**Arid Lands Environment Centre's submission on the Draft Western
Davenport Water Allocation Plan**

Sunday 14 May 2023

Figure 26. Modelled salinity (expressed as electrical conductivity, $\mu\text{S}/\text{cm}$) of the saline layer at the top of the aquifer (Scenario 1, No Recycling), assuming $c_0 = c_G$. It is estimated using Equation 12.

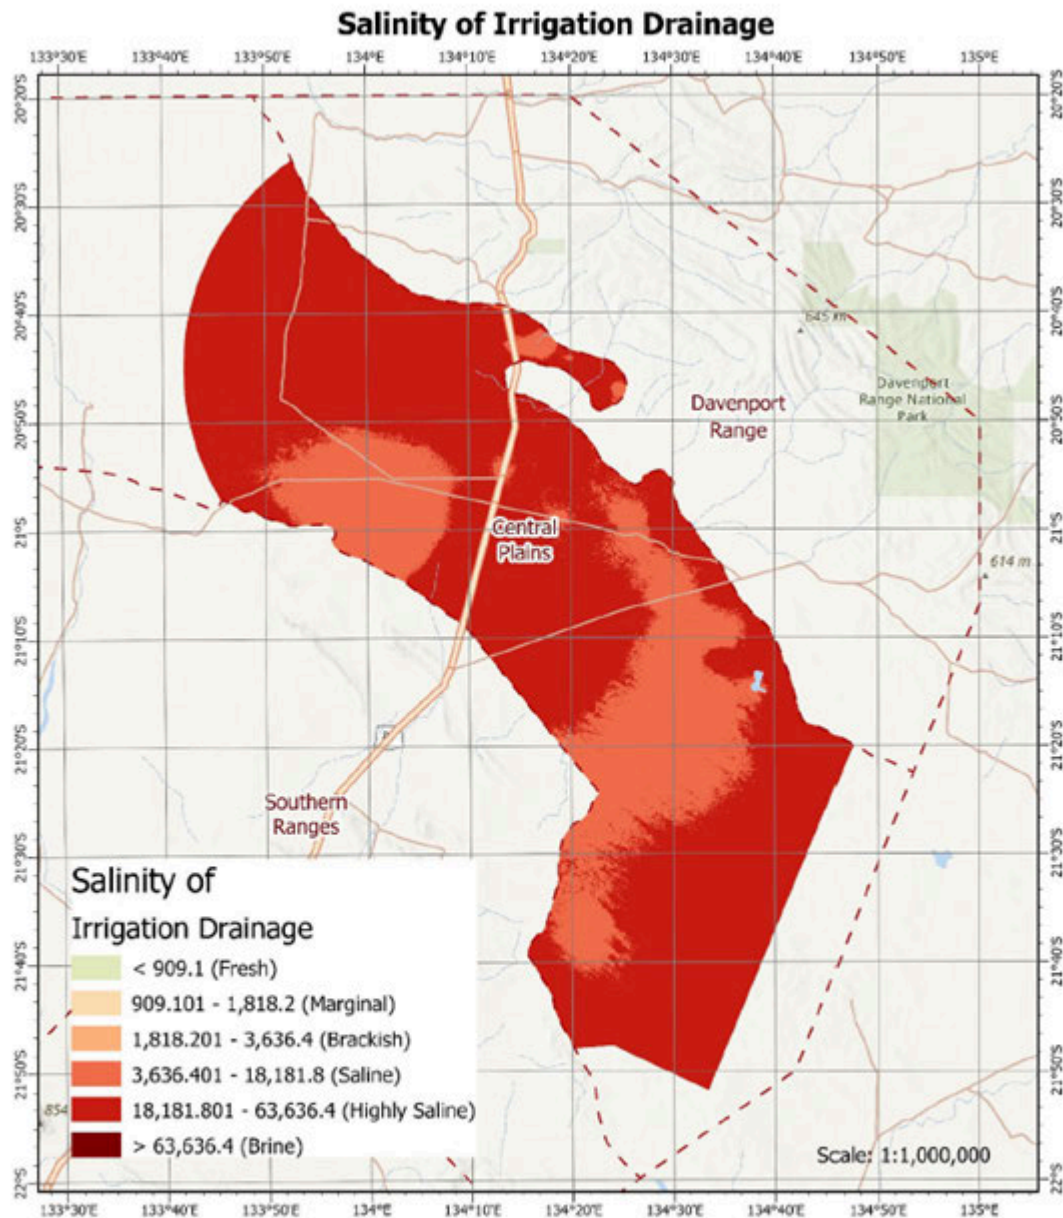
107. ALEC’s position: Extraction of over 80 GL/year inevitably will bring huge amounts of salt to the surface. These risks are poorly understood and the statutory WAP offers no commentary or guidelines, whatsoever that the Controller could take into consideration in assessing groundwater extraction licence applications. Salt contamination is a major risk to water resources for environment, public water supplies and long-term agricultural use. These risks are too large, poorly evaluated and with no management arrangements in place. These risks warrant a significantly lower ESY and management guidance within the statutory WAP.
